BOILER SAFETY REPORT

Newage Garments Ltd.

Factory ID: 9603

FINDING NO:	B-53

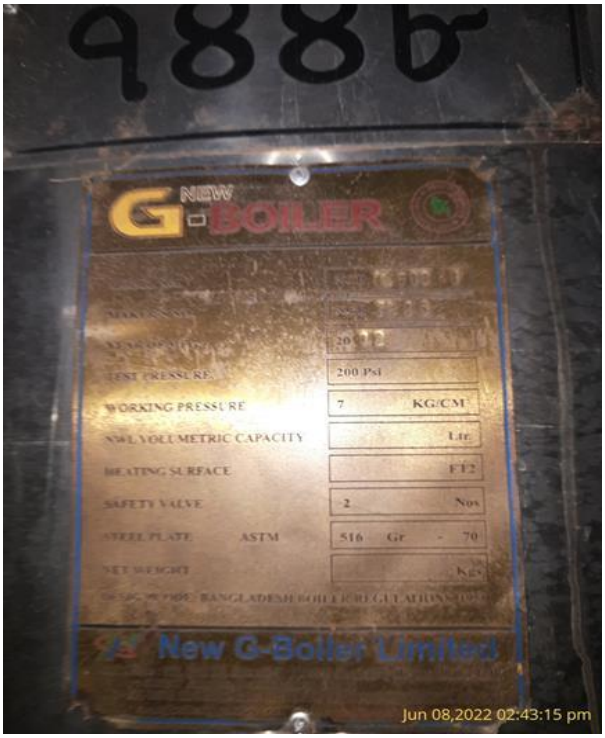
CATEGORY:	Identification	
BOILER REGISTRATION NO:	BB 7446	
FINDING: Inconsistency was observed between the nameplate data and the CIoB provided certificate copy for the boiler regarding manufacturing year.		
RECOMMENDATION: Information provided in the nameplate and in the CIoB provided certificate shall be consistent. Any alteration shall be approved from the CIoB and a copy to be preserved on site.		
PRIORITY:	P2	
REMEDIATION TIME FRAME:	2 MONTHS

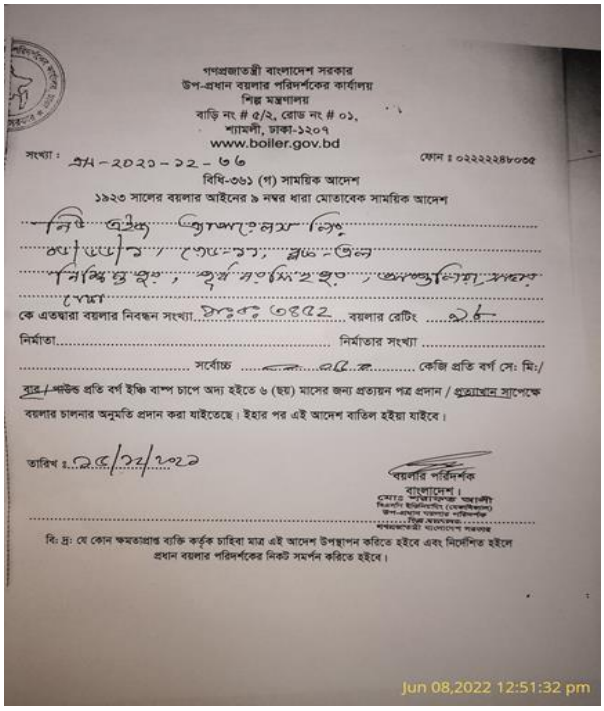
FINDING NO:	B-65
CATEGORY:	Documentation
BOILER REGISTRATION NO:	BB 6336
FINDING: Boiler's initial registration certificate was not available on-site during the inspection.	
RECOMMENDATION: Boiler registration certificate from the government authority which was provided after the installation shall be available on-site during the inspection.	
PRIORITY:	P3
REMEDIATION TIME FRAME:	2 MONTHS

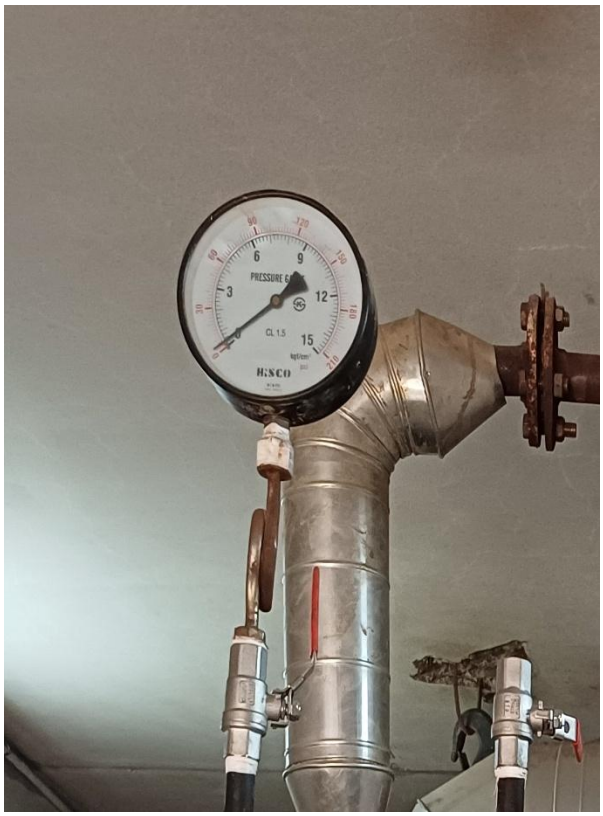
FINDING NO:	B-68
CATEGORY:	Monitoring and Control System
BOILER REGISTRATION NO:	BB 13066
FINDING: The steam pressure gauge range was insufficient.	
RECOMMENDATION: The boiler pressure gauge range should be at least twice the boiler's maximum allowable working pressure mentioned in the boiler license or in accordance with any recognized international standard.	
PRIORITY:	P2
REMEDIATION TIME FRAME:	1 MONTH

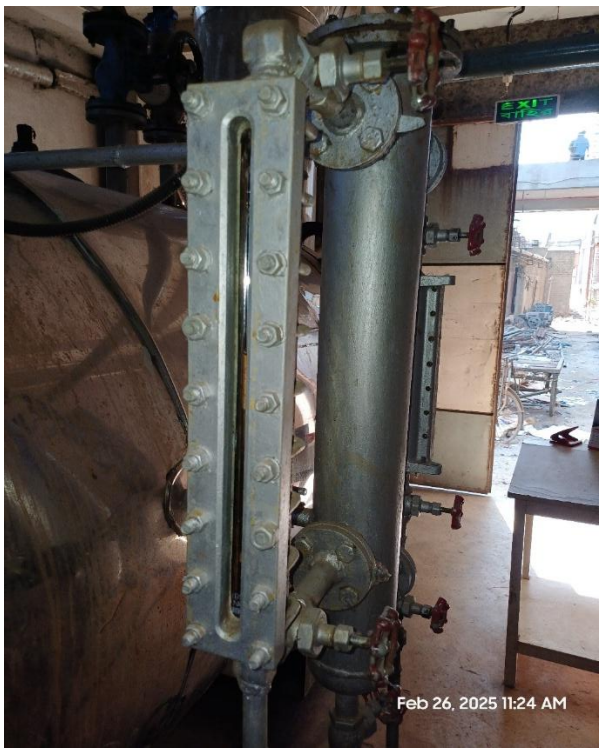
FINDING NO:	B-73
CATEGORY:	Monitoring and Control System
BOILER REGISTRATION NO:	BB 14856
FINDING: Low Low Water Level (LLWL) was not marked properly on water level gauge glass system.	
RECOMMENDATION: The Low Low Water Level (LLWL) should be marked beside the gauge glass on a separate arrangement so that the water level can be visualized and identified clearly.	
PRIORITY:	P3
REMEDIATION TIME FRAME:	2 MONTHS

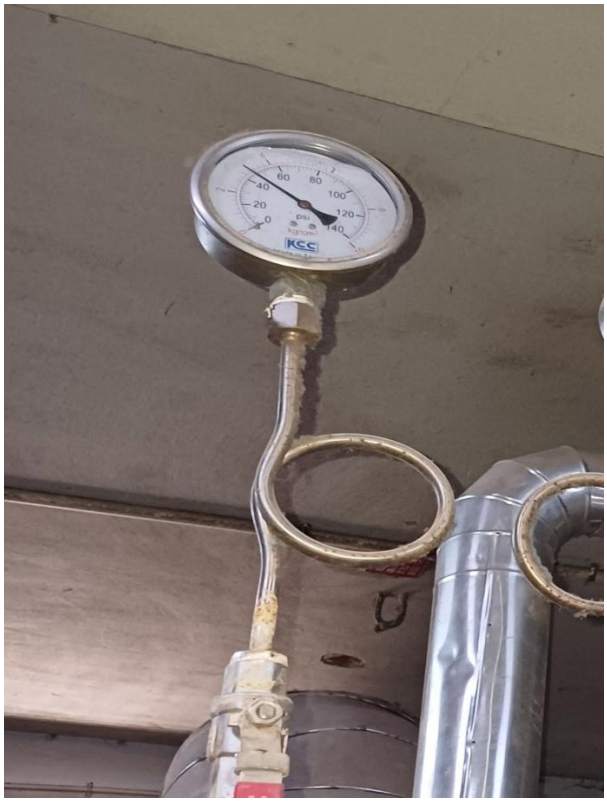
FINDING NO:	B-76
CATEGORY:	Monitoring and Control System
BOILER REGISTRATION NO:	BB 14856
FINDING: The steam pressure gauge range was insufficient.	
RECOMMENDATION: The boiler pressure gauge range should be at least twice the boiler's maximum allowable working pressure mentioned in the boiler license or in accordance with any recognized international standard.	
PRIORITY:	P2
REMEDIATION TIME FRAME:	1 MONTH

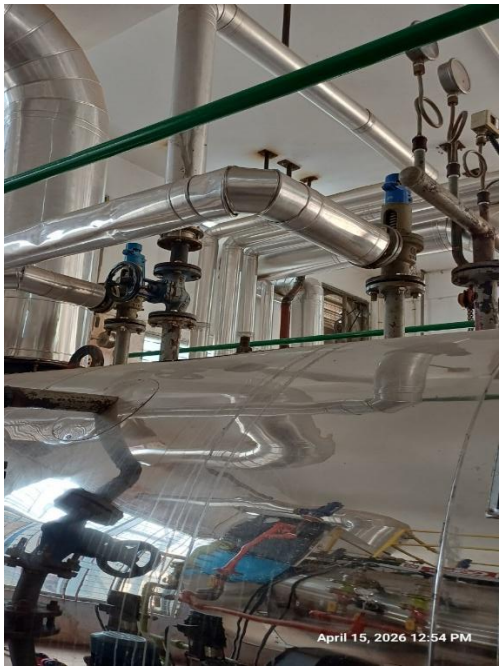
FINDING NO:	B-80
CATEGORY:	Safety Valve
BOILER REGISTRATION NO:	BB 14856
FINDING: Drainage arrangement was not installed or installed in an inadequate manner for one or more safety valves.	
RECOMMENDATION: Drainage arrangement must be installed for all safety valves as per manufacturer published guideline or at the lowest point of outlet line.	
PRIORITY:	P3
REMEDIATION TIME FRAME:	2 MONTHS

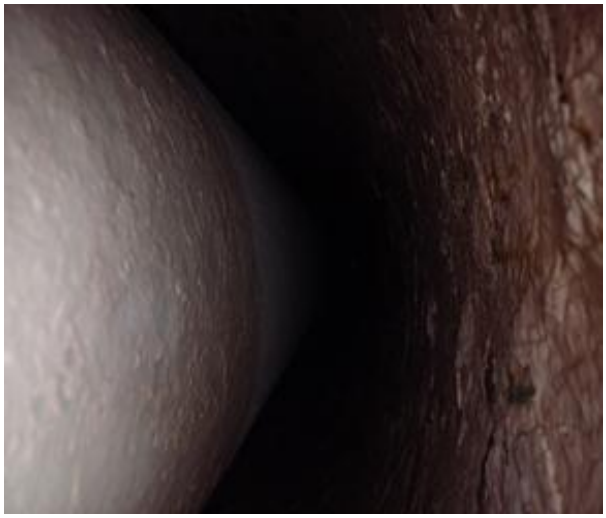
FINDING NO:	B-95
CATEGORY:	Scales and Deposits
BOILER REGISTRATION NO:	BB 7448
FINDING: Salt and scale formation was observed on the waterside of the boiler.	
RECOMMENDATION: Cleaning is required. A water treatment station is to be used. Feed and boiler water quality and conditioning should be verified and monitored. The boiler operator should operate the boiler with proper blowdown.	
PRIORITY:	P2
REMEDIATION TIME FRAME:	1 MONTH

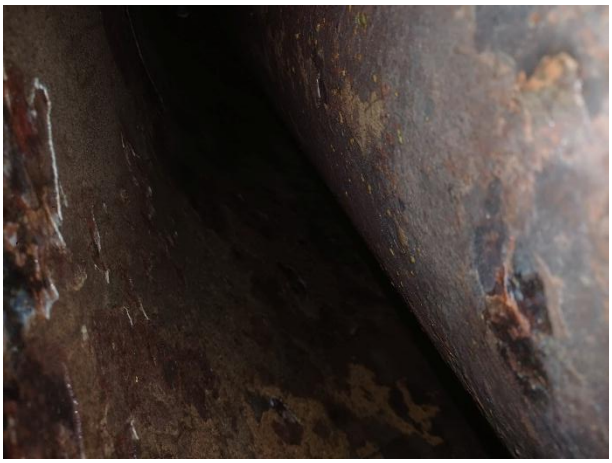
FINDING NO:	B-99
CATEGORY:	Scales and Deposits
BOILER REGISTRATION NO:	BB 6336
FINDING: Salt and scale formation was observed on the waterside of the boiler.	
RECOMMENDATION: Cleaning is required. A water treatment station is to be used. Feed and boiler water quality and conditioning should be verified and monitored. The boiler operator should operate the boiler with proper blowdown.	
PRIORITY:	P2
REMEDIATION TIME FRAME:	1 MONTH

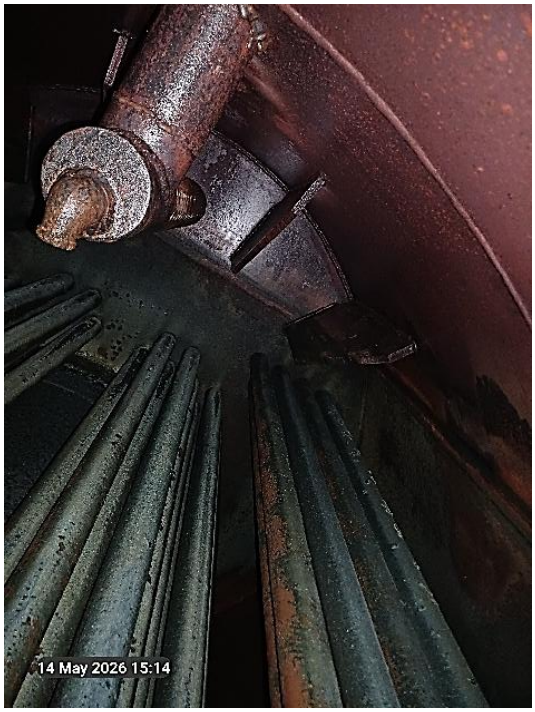
FINDING NO:	B-100
CATEGORY:	Scales and Deposits
BOILER REGISTRATION NO:	BB 15346
FINDING: Salt and scale formation was observed on the water side of the boiler (Furness tube, end plate, and the bottom end plate). Nature of scale is thin (1 mm).	
RECOMMENDATION: Cleaning is required. A water treatment station is to be used. Feed and boiler water quality and conditioning should be verified and monitored. The boiler operator should operate the boiler with proper blowdown.	
PRIORITY:	P2
REMEDIATION TIME FRAME:	1 MONTH
